AWD Warning Light ON DTC C13F800

Service Category Drivetrain

Section Transfer/4wd/Awd

YEAR(S)	MODEL(S)	ADDITIONAL INFORMATION
2019	RAV4

Figure 1. Location of Authorized Modifications Label on 2019 RAV4

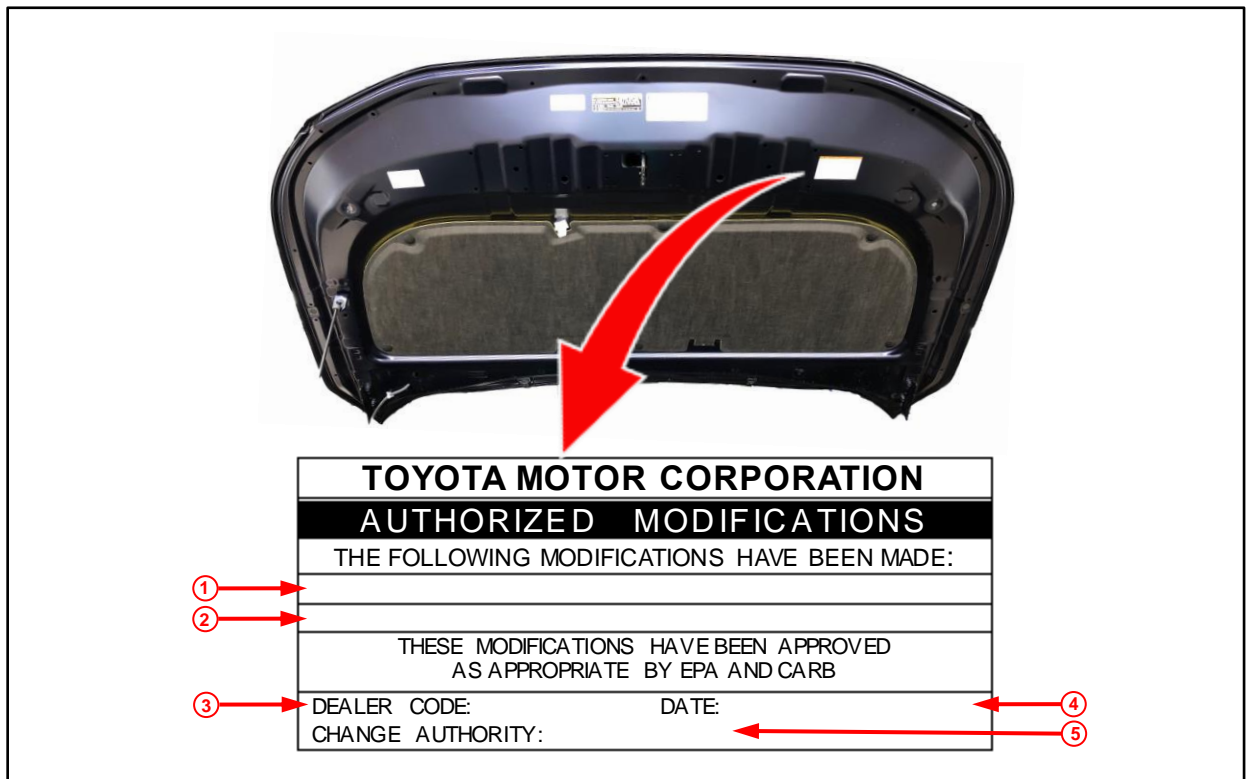
4. Prepare and install the Authorized Modifications Label.

A. Using a permanent marker, enter the following information on the label:

- 4WD ECU part number [*Refer to the **Parts Information** section for the **NEW PART NUMBER***]
- Calibration ID(s) [*Refer to the **Calibration Information** section for the **NEW CALIBRATION ID***]
- Dealer Code
- Repair Date
- Change Authority [***This bulletin number***]

B. Install the Authorized Modifications Label onto the vehicle at the location shown in Figure 1. The Authorized Modifications Label is available through the MDC, P/N 00451-00001-LBL.

Figure 2. Rear Differential Serial Number Location

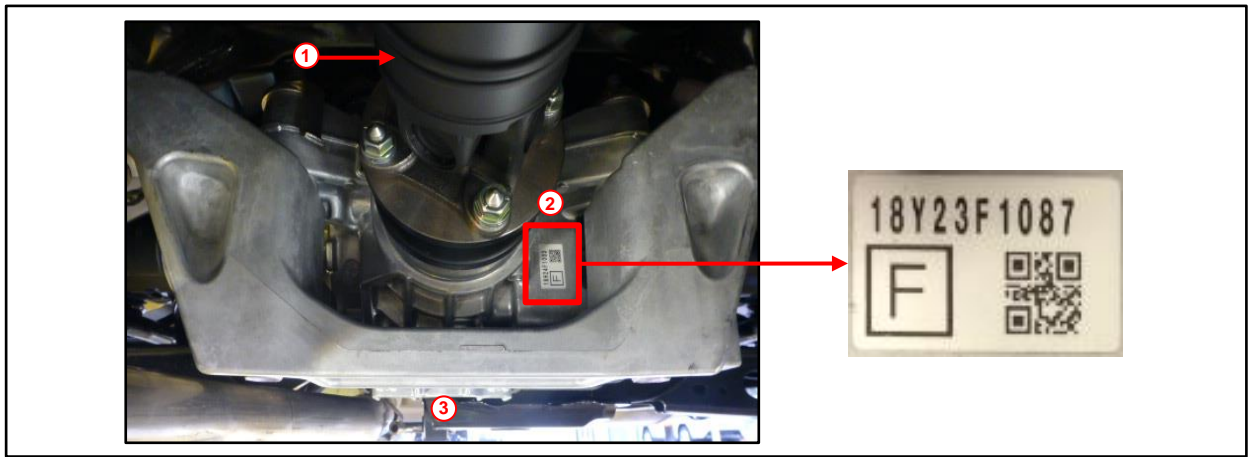
5. Confirm the rear differential production date (serial number).
Is the rear differential production date on or before February 14, 2019?
 - **YES** — Continue to step 6.
 - **NO** — Rear differential replacement is NOT necessary. Go to step 7.

6. Replace the rear differential carrier assembly.
